Re: Application number SSD-10342

Please find below our submission regarding the above referenced Application currently on the major projects website for review and feedback.

The Royal Agricultural Society of NSW (RAS) are located at Sydney Showground, Sydney Olympic Park and are a very close neighbour of Stadium Australia. We are pleased to provide the following comments concerning the material on exhibition.

Fig 52 from the EIS

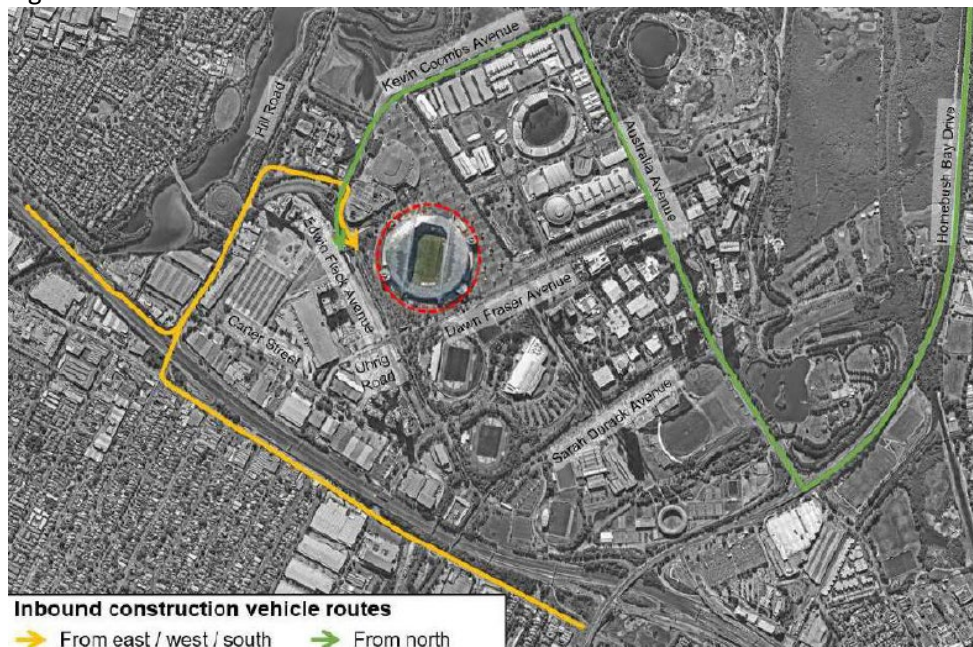
1. As detailed in Fig 52 of the EIS and in various other reports, we note the proposed inbound construction routes from the North along Australia Avenue. Please be advised that for approximately 35 days in and around Easter to facilitate the requirements of the annual Sydney Royal Easter Show (SRES), Australia Avenue from Murray Rose Avenue to Kevin Coombs Avenue is completely closed and will be unavailable to the aforementioned development.

Figure 51 Proposed temporary construction compound

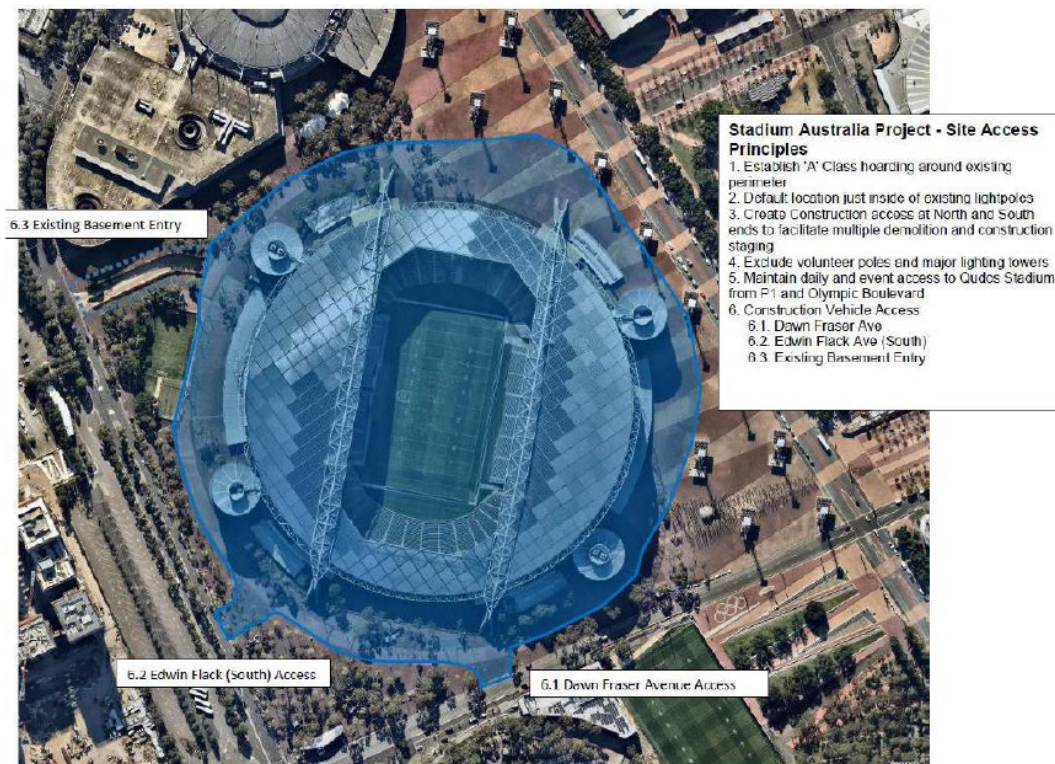
2. We also note the proposed construction boundary fence identified in Fig 51 of the EIS and again in various other reports and advise that discussion and agreement with both the RAS and SOPA will be required as it appears that the proposed boundary to the north west of the site may impact detrimentally on the boundary line of the annual SRES. The RAS would welcome the opportunity to have constructive discussion with the Department to ensure the development can be safely secured without detrimentally affecting the Nation's largest annual ticketed event.
